ADDENDUM NO. 2

Date:	June 24, 2008
To:	Contractors
From:	Jim Russell, Project Manager, DFCM
Reference:	Richfield UHP/DTS Alternate Dispatch Modification Department of Public Safety – Richfield, Utah DFCM Project No. 06298550
Subject:	**Addendum No. 2**

Project Name: Department of Safety Richfield
U.H.P. - I.T.S Dispatch Modifications

Addendum No.: 2

SE-1

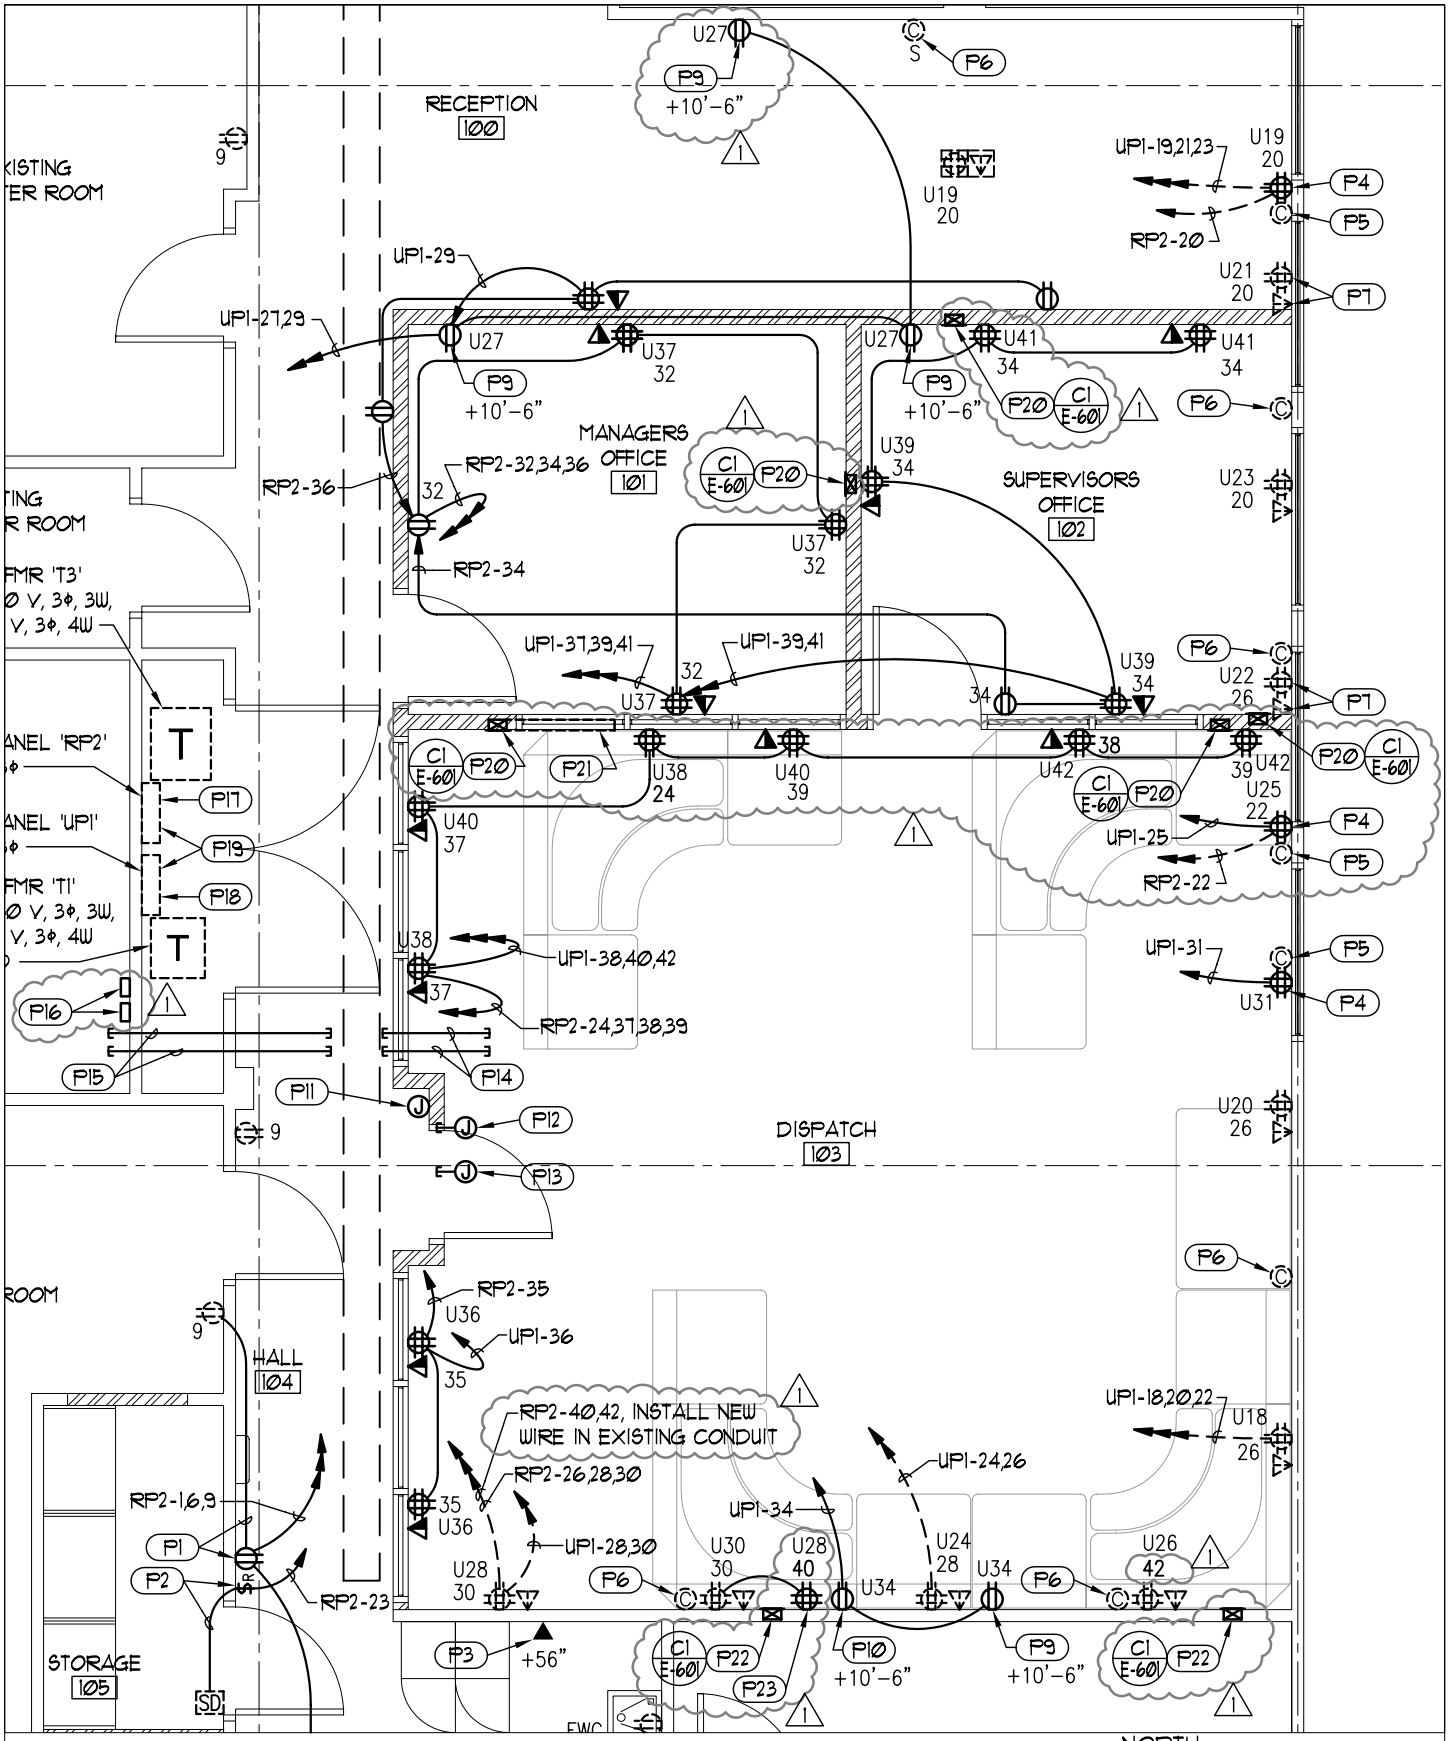
A. Add flush mounted wall duct for owner furnished communication cables in Rooms 101, 102 and 103 as shown attached Partial New Power Plan, Supplemental Electrical Drawing SE-1, and indicated by Revision No. 1.

A. Modify receptacle circuiting in Dispatch 103 as shown attached Partial New Power Plan, Supplemental Electrical Drawing SE-1, and indicated by Revision No. 1.

1) Provide minimum 2 different circuits from Panel UP1 at each Dispatch Work Station.

2) Connect one receptacle at each Dispatch Work Station to a separate circuit from Panel 'RP2' for plug-in electric heater which dispatchers may use.

C1 WALL DUCT DETAIL

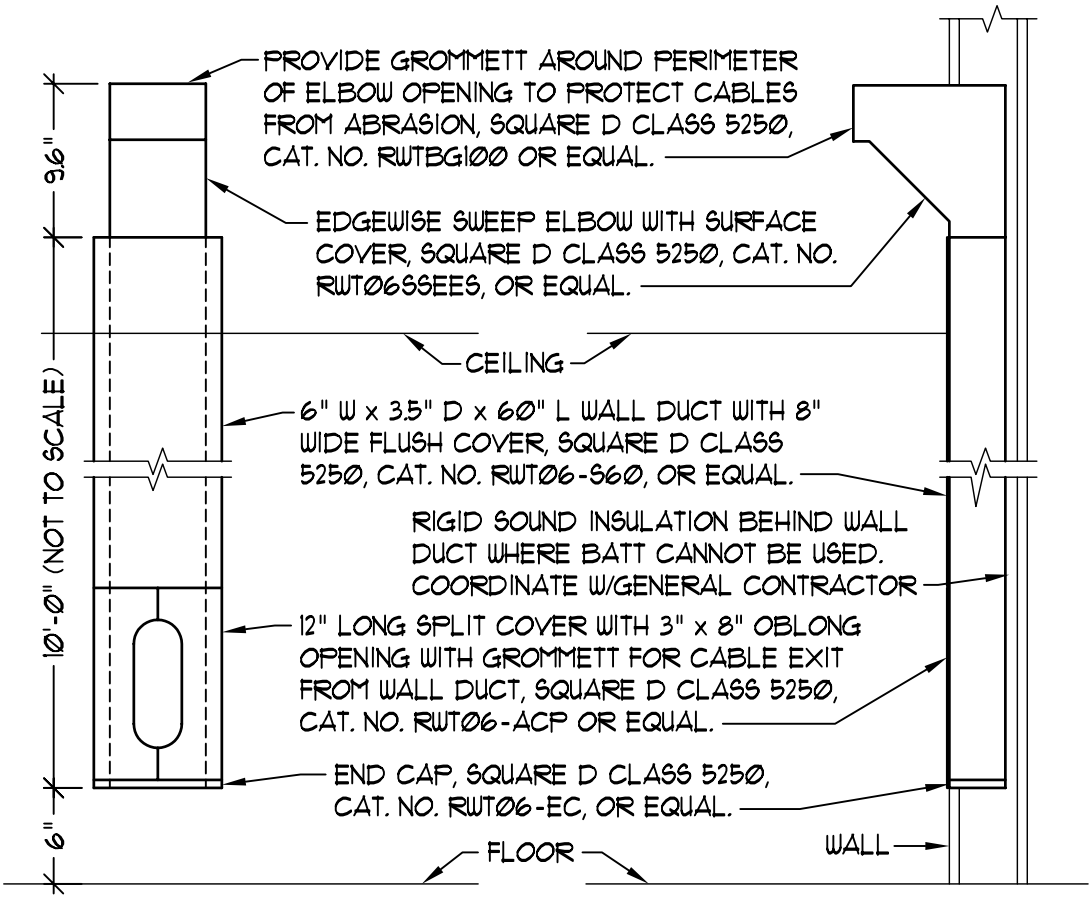
Drawings: Supplement Electrical Drawing SE-1: Partial New Power Plan
Supplement Electrical Drawing SE-2: Partial New Power Plan Keyed Notes
Supplement Electrical Drawing SE-3: Wall Duct Detail C1/E-601.

P22 PROVIDE NEW FLUSH MOUNTED WALL DUCT IN EXISTING WALL SIMILAR TO DETAIL C1/E-601. FIELD COORDINATE EXACT LOCATION WITH ENGINEER, GENERAL CONTRACTOR, AND OWNER. RELOCATE AND RECONNECT ANY EXISTING HORIZONTAL CONDUIT RUNS AS REQUIRED TO INSTALL THE NEW WALL DUCT. REPAIR EXISTING WALL AS REQUIRED TO MATCH SURROUNDING SURFACES.
